Site Observation Visit# 03

Report #03-Mockup-Phase 1

Project Name: Webster University- ISB
Project Location: Webster Groves
Project Number: 2014061.20
Client: Webster University
Report Prepared By: George Crow - Heitmann & Associates, Inc.
Date of Report: October 7, 2016

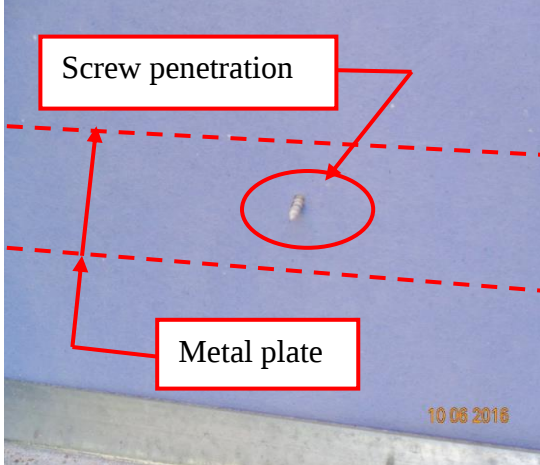
DATE	DESCRIPTION		COMMENTS/ RESOLUTION	STATUS
10-6-16	View of mockup exterior identifying termination bar location. –Screw spacing of termination bar is 8 inches o.c.		Paric to verify that metal plate is installed on the building at all required locations.	Mockup development in progress
10-6-16	View inside face of mockup		Paric-verify if metal plate can be added to mockup.	Mockup development in progress
10-6-16	Close up of screw penetration at inside of mock up		Paric-verify if metal plate can be added to mockup.	Mockup development in progress
